**KGHM AJAX MINE INC.**

## **DAM SAFETY REVIEW AFTON TAILINGS STORAGE FACILITY**

VA101-246/16-2  
Rev 0  
March 28, 2014

**PHOTO 9** – Eroded section of the southwest seepage dam repaired in October 2013.

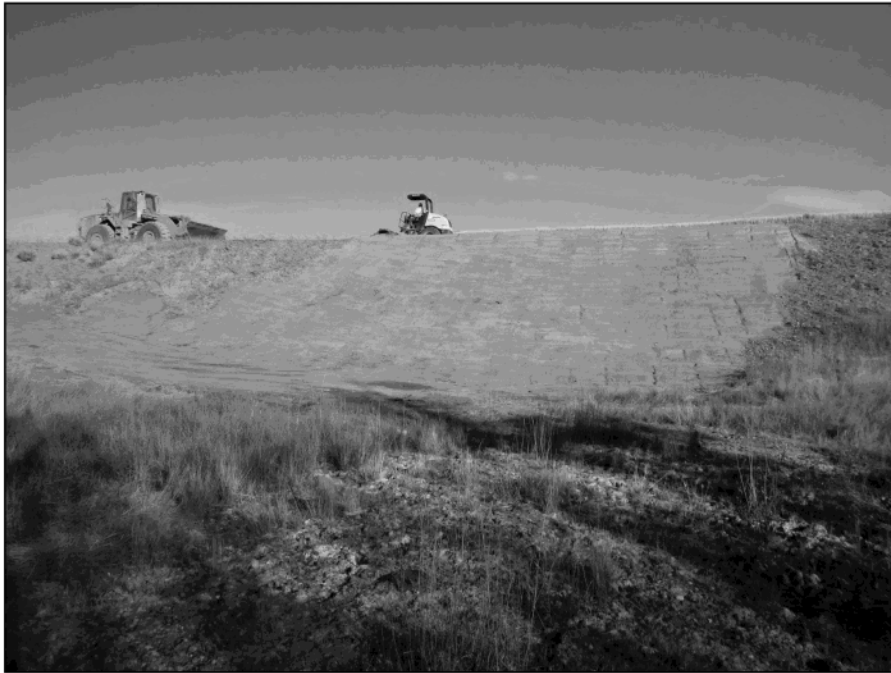
The southwest seepage dam is a small dam located downstream of the southern end of the TSF West Dam. The southwest seepage dam has a very small upstream catchment and primarily collects surface runoff from the downstream face of the Afton TSF West Dam; the ponded area upstream of the dam is typically dry. The dam overtopped in May, 2011 following a storm event and subsequent failure of the upslope Alkali diversion channel which diverts surface flows from an upstream catchment area of approximately 53 km<sup>2</sup>. This resulted in the erosion of a portion of the dam downstream slope (photo 8).

KGHM contracted Dawson Construction, a local contractor, to complete the repair work in October 2013. KGHM also contracted KP to provide construction Quality Assurance and to document the work. The dam was repaired (photo 9) and a construction quality assurance report was issued to KGHM (Knight Piésold 2013b).

**PHOTO 10** – Plywood gate and debris blocking outlet at northwest seepage dam.

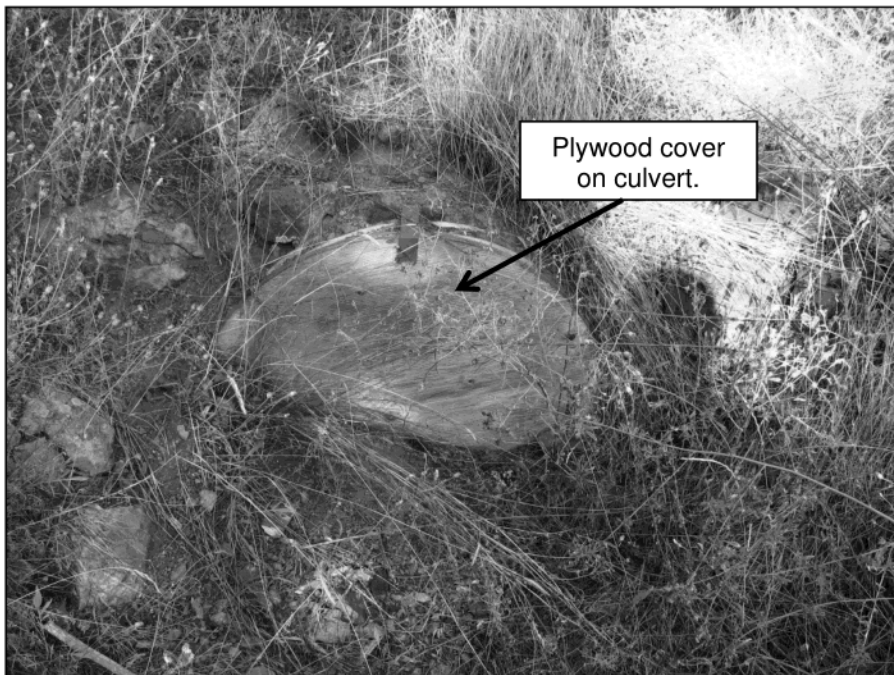
A recommendation from the 2009 DSR was to clean up the inlet such that the plywood barrier could be removed during a flood event. Removing the plywood barrier during a flood event may be difficult

(it is bolted on) and it is recommended KGHM explore alternative plans to safely pass flood events from the northwest seepage pond during storm events.

5. The plywood gate blocking the outlet pipe for the northwest seepage dam should be cleared of debris and vegetation so that it can be removed in short-notice to release water downstream of the dam to prevent overtopping.

**PHOTO 11** – Alkali diversion channel, undercut section. Diversion channel modifications/repair planned for 2014.

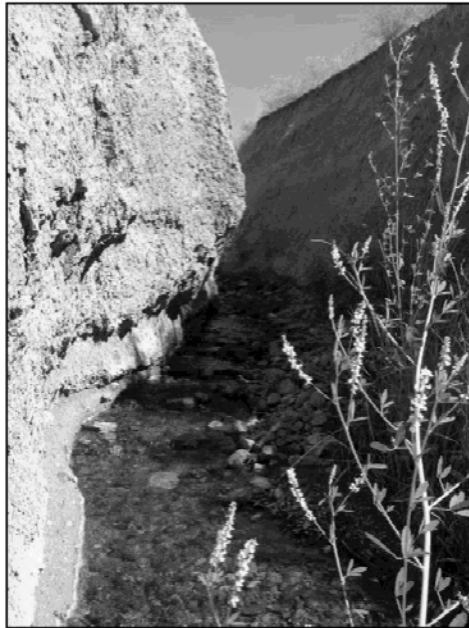
The Alkali diversion channel is located on the south side of the TSF and diverts flows from Alkali Creek downstream of the southeast seepage dam into Cherry Creek. The diversion channel is undercut in places (photo 11) and there is a risk the side slopes will slough into the channel during a high flow event in the channel as occurred in 2011. It is recommended the Alkali diversion channel be refurbished to safely pass the design flow. KGHM has plans to upgrade the Alkali diversion channel in spring of 2014. A hydrologic study and channel design have been completed for this work by Knight Piésold.

6. The section of the Alkali diversion channel to the west of the TSF is in need of repair as it has eroded down to bedrock in places and has over steepened side slopes. There is a risk the side slopes will slough into the ditch during a high flow event. This occurred in 2011 and the resultant discharge overtopped and eroded a section of the southeast seepage pond.
